Re: 40 Trinity Place, Boston, Massachusetts

BOSTON REDEVELOPMENT AUTHORITY  
SCOPING DETERMINATION

40 TRINITY PLACE – BOSTON, PROJECT NOTIFICATION FORM

# STUDY POINTS FOR WIND ANALYSIS

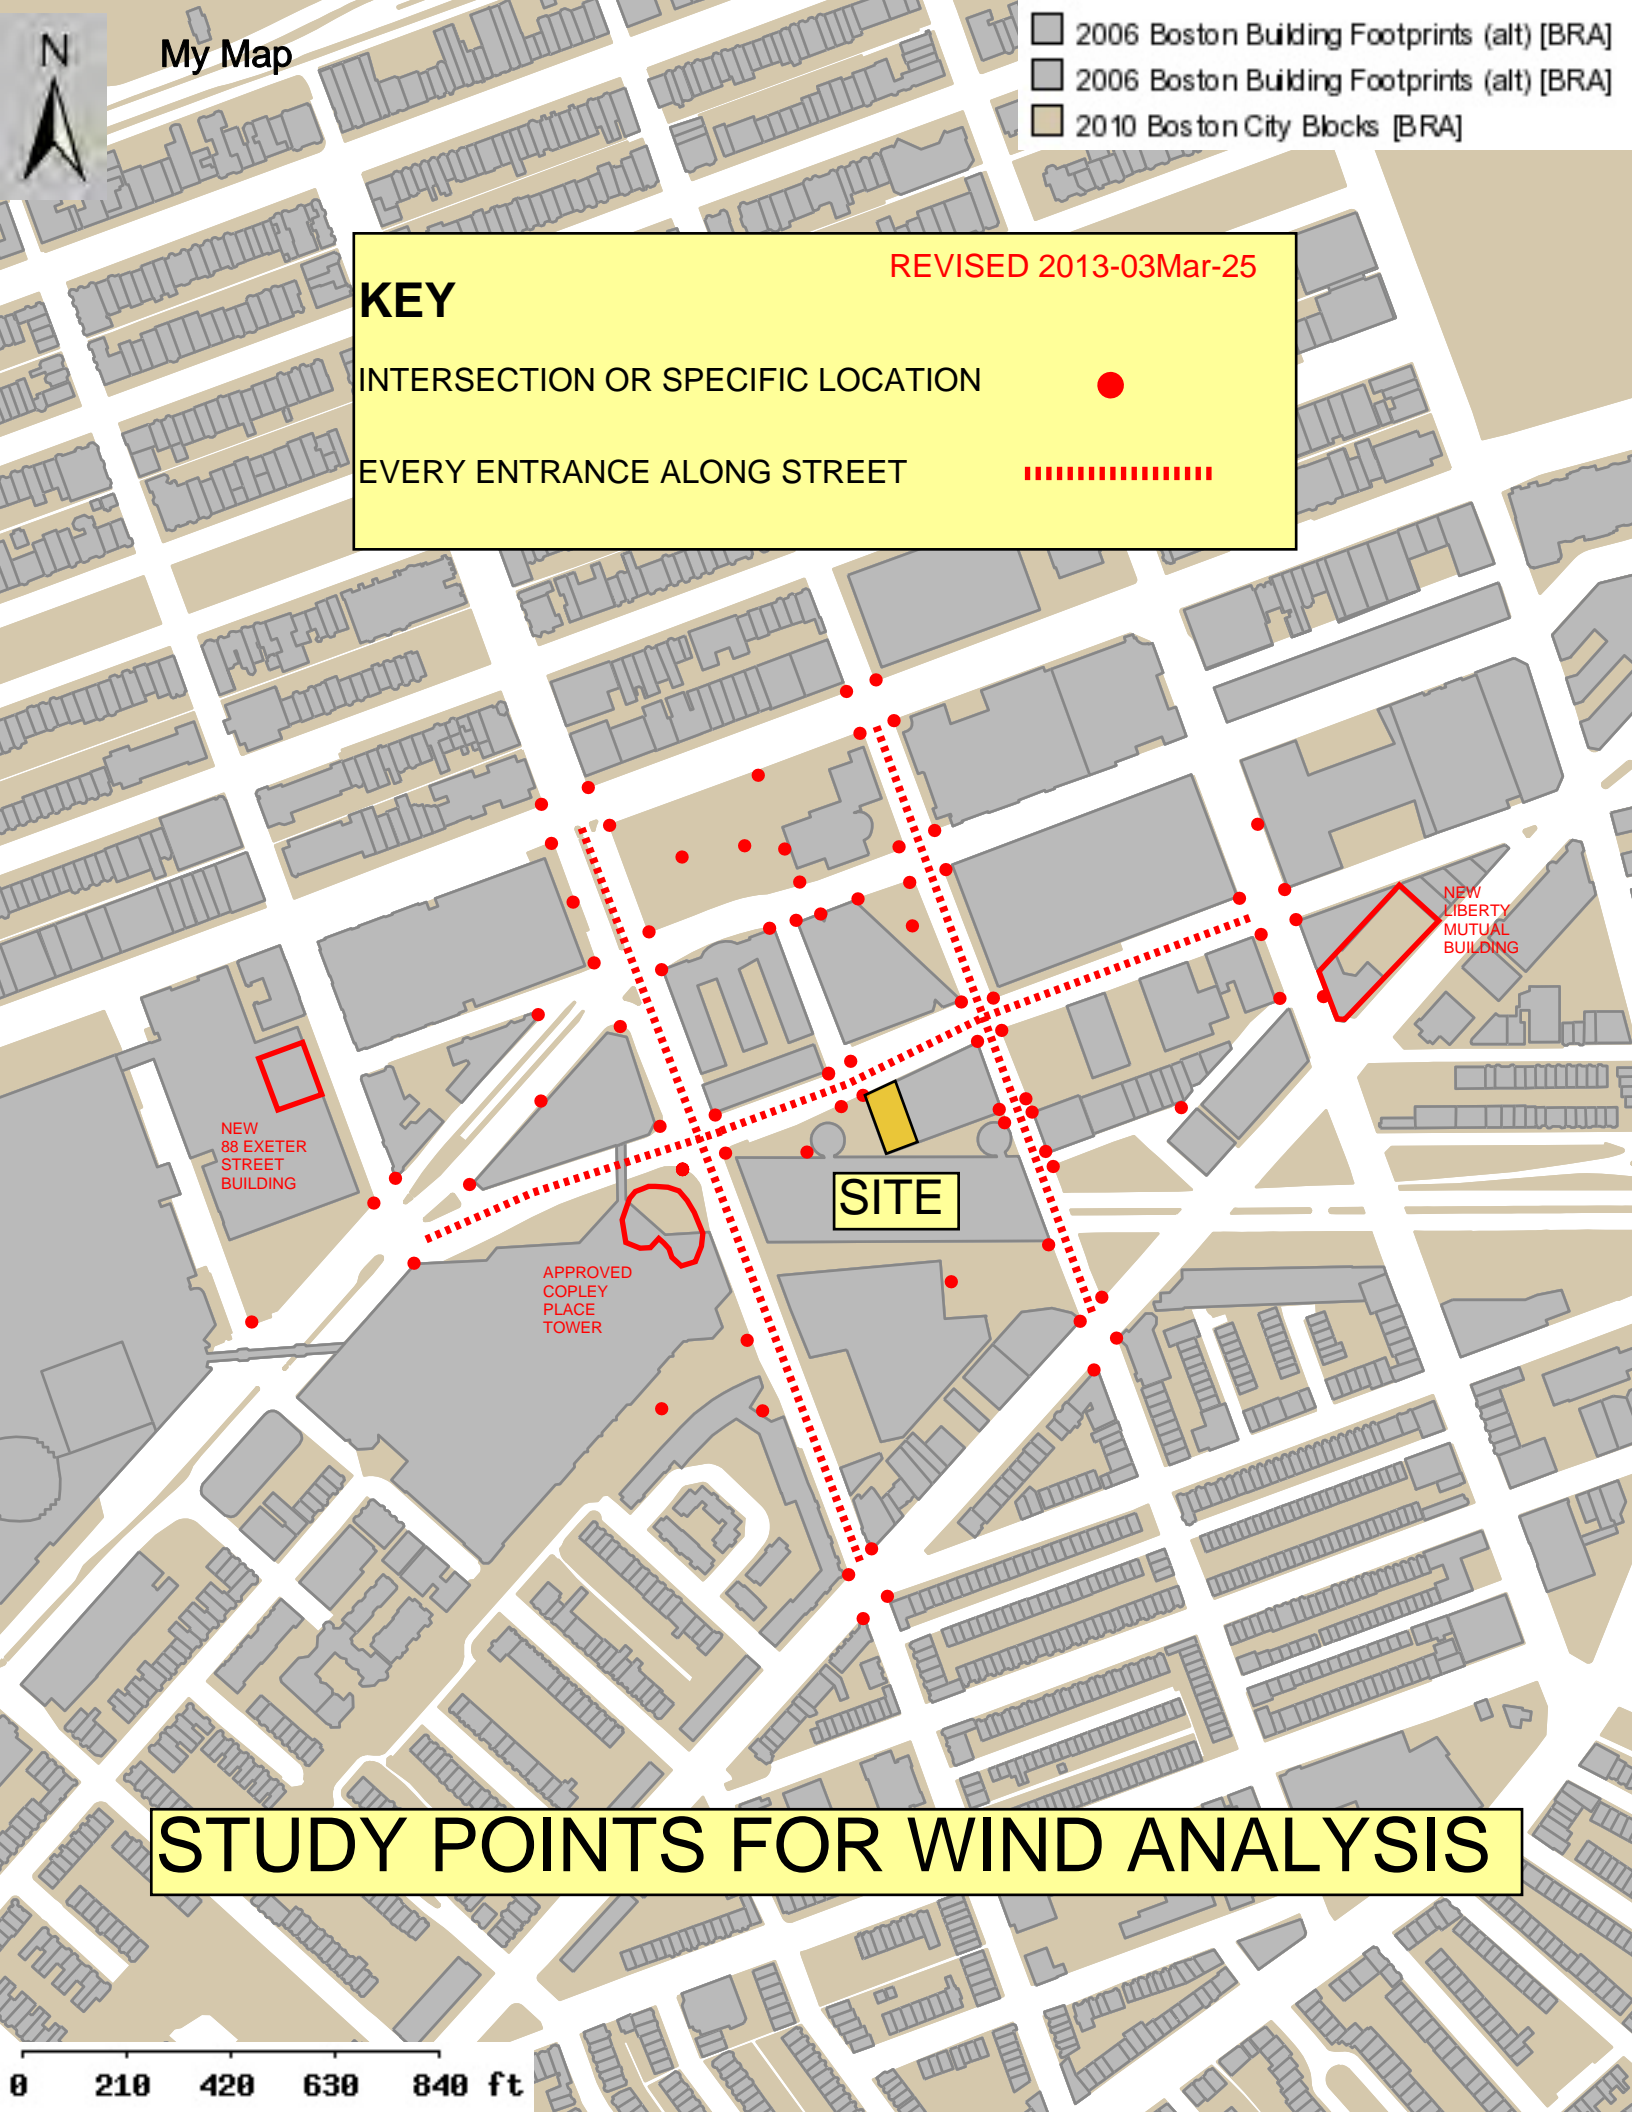
blocks of the property in question; especially where contiguous to open space, analysis may extend to likely bounds of no impact. Analysis of results and effective mitigation shall be presented in the DPIR using diagram methodology so that the delta or changes manifested by the project relative to existing or as-of-right conditions...again, whichever provides the higher base impacts...are clearly understood. See Appendix 6 for required wind study points.
